Revisions			
P01	28.06.16	PLANNING ISSUE	AE PY
P02	14.07.16	REVISED PLANNING ISSUE	KI PY
P03	09.03.17	PLANNING AMENDMENT SUBMISSION	NH LP

**PLANNING AMENDMENTS**

Client  
**RFU**  
 Project  
**TWICKENHAM STADIUM EAST STAND EXTENSION**  
 Drawing title  
**GA SECTIONS**

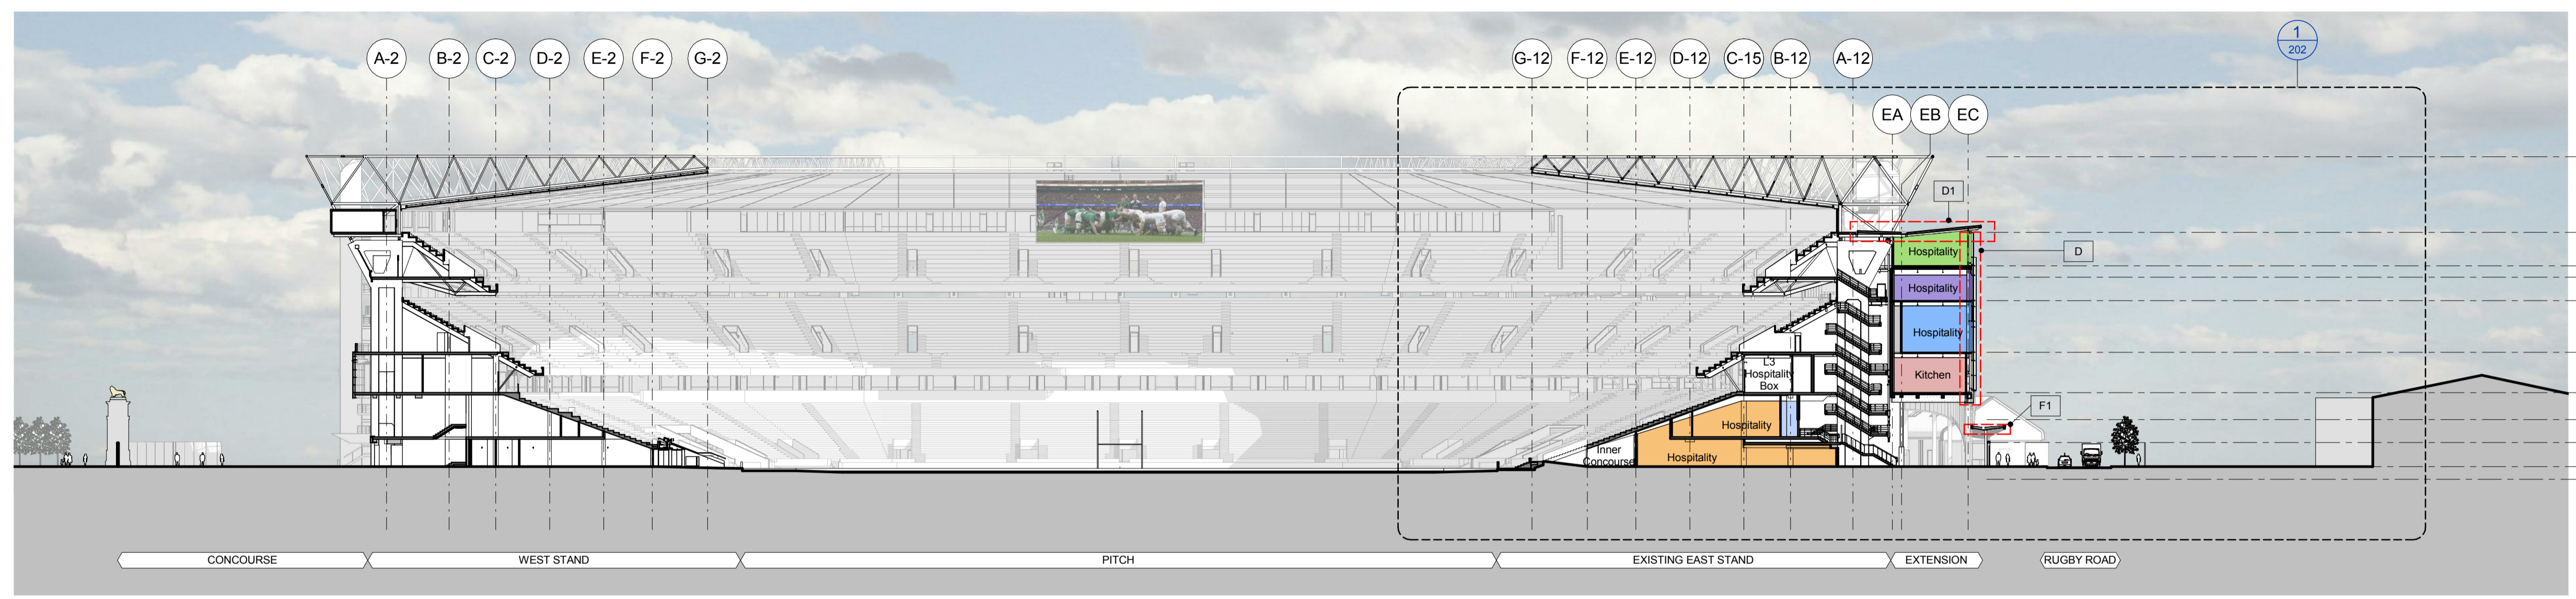
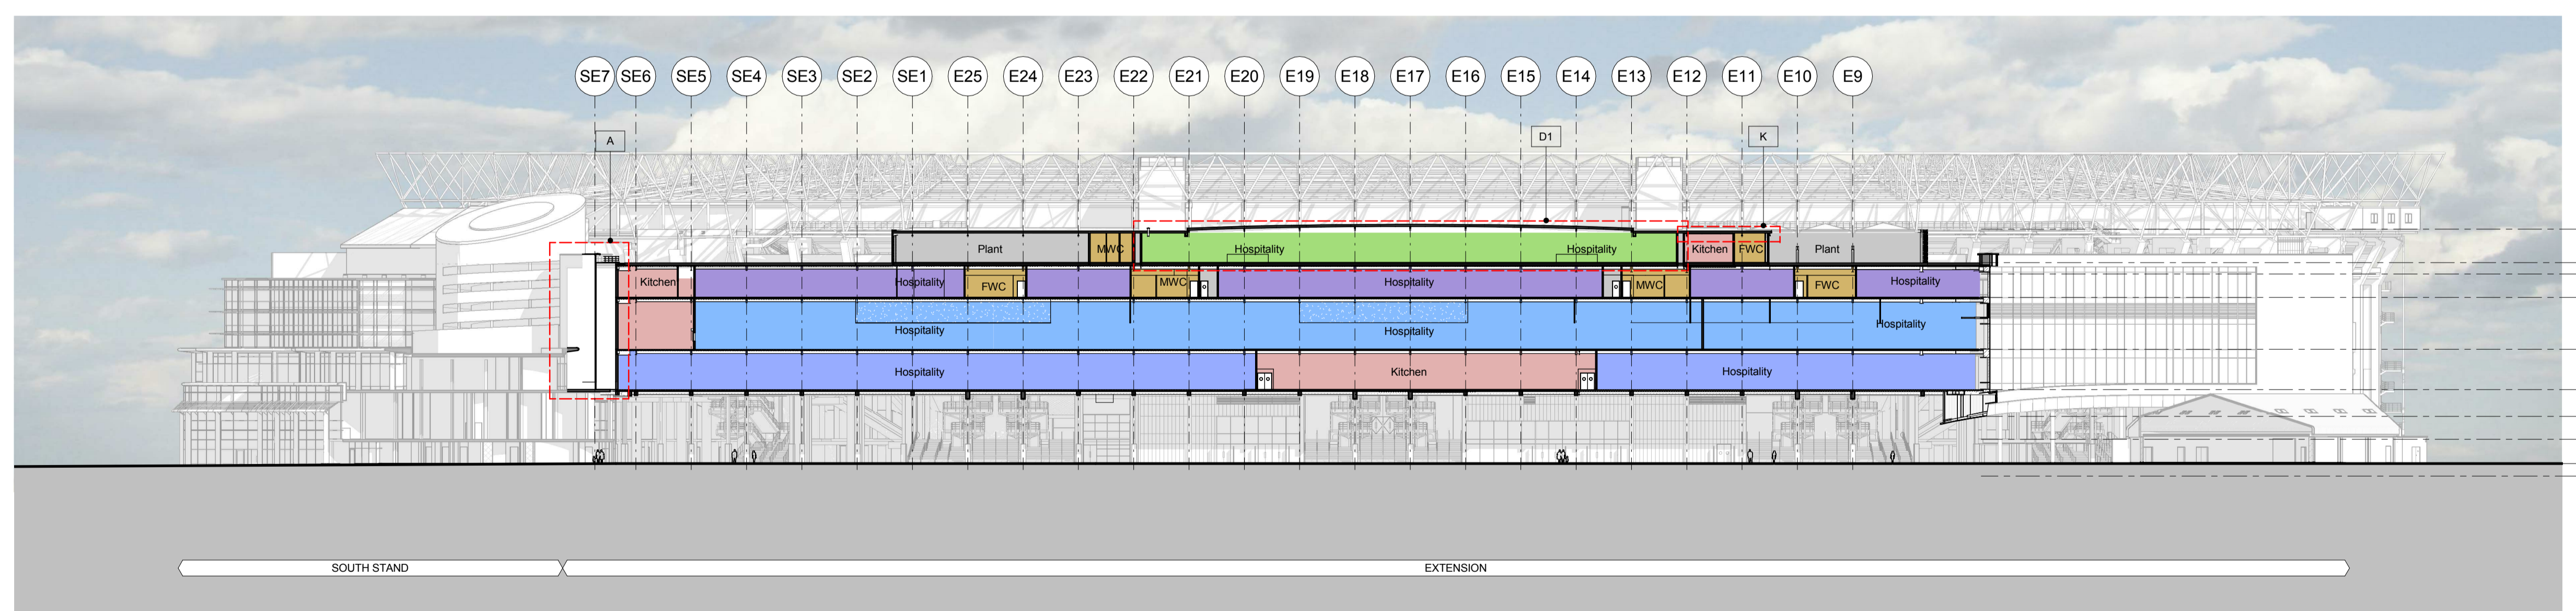
- A GENERAL AMENDMENTS TO THE SOUTH END.
- A1 INCREASED SHINGLES CLADDING AREA AND CURTAIN WALL REDUCED ACCORDINGLY.
- A2 REDUCED MASSING AND REVISED INTERFACE WITH THE SOUTH STAND.

- B PPC LOUVRES LOCATED TO THE BOWL SIDE HAVE BEEN OMITTED.
- C CURTAIN WALL SETTING OUT REVISED GENERALLY. SILICONE JOINTS TO TRANSOMS AND MULLION REPLACED WITH CAPPED SYSTEM. LEVEL 04 PPC LOUVRES: SETTING OUT & HEIGHT REVISED. MONORAIL FOR ABSEILING REMOVED.

- D GENERAL AMENDMENTS TO THE CENTRAL ELEVATION CANOPY AT LEVEL 5A REVISED GENERALLY AND STANDING SEAM REPLACED WITH SINGLE PLY MEMBRANE. SUPPORT COLUMNS TO ROOF CANOPY REVISED. SQUARE FASCIA TO ROOF EDGE.

- D1 LEVEL 5A GLAZED SCREEN EXTENDED IN HEIGHT AND PPC LOUVRES INCLUDED AT LOW LEVEL.
- D2 INCREASED SHINGLES CLADDING AREA AND CURTAIN WALL AREA REDUCED ACCORDINGLY. FOUR VERTICAL FINIS REMOVED.

- D3 PORCELAIN PANELS WITH SLOTTED HOLES FOR VENTILATION REPLACED WITH PPC LOUVRES. EXPRESSED HORIZONTAL PATTERN TO PORCELAIN PANELS OMITTED.
- E GENERAL AMENDMENTS TO THE NORTH END PORCELAIN CLADDING REPLACED WITH PPC ALUMINIUM CLADDING.

- E1 GREEN WALL TO THE NORTH END EXTENDED AND PPC LOUVRES REMOVED.
- E2 INCREASED SHINGLES CLADDING AREA AND CURTAIN WALL REDUCED ACCORDINGLY.
- E3 FENCELINE, GATE AND PERIMETER COLUMNS SETTING OUT REVISED.

- F1 CANOPY TO TURNSTILES REVISED.
- G PORCELAIN PATTERN CHANGED FROM HORIZONTAL TO VERTICAL.
- H PORCELAIN PANELS TO THE SOFFIT OF THE ARCH REPLACED WITH PPC ALUMINIUM PANELS. PORCELAIN PANELS SETTING OUT REVISED.

- K ROOF TO LEVEL 5A (NORTH END) EXTENDED.
- L GLAZED SPANDREL PANELS REPLACED WITH METAL SPANDREL PANEL. PORCELAIN PANELS REPLACED WITH PPC ALUMINIUM CLADDING.

- L1 PPC LOUVRES INCLUDED FOR MECHANICAL VENTILATION.
